Service Bulletin

Bulletin No.: 10-07-30-001D

Subject: Fluid/Oil Leak During Cold Weather from Transmission Vent

Models: 2001-2013 Chevrolet Silverado 2500HD-3500HD Series

1377427

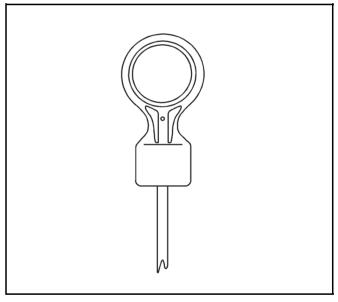
Important: Ensure that the fluid level is at the top of the HOT band when the transmission fluid temperature is 79°C (175°F). Refer to SI Document ID# 2408059 for the proper fluid level checking procedure.

Note: The fluid level on the indicator may be higher on one side than the other. The lower reading should be considered the actual fluid level. The higher fluid level on the indicator should be considered splash.

Note: Only on 2001-2004 models, replace the transmission fluid indicator (dipstick) with a new vented indicator. P/N 15794381.
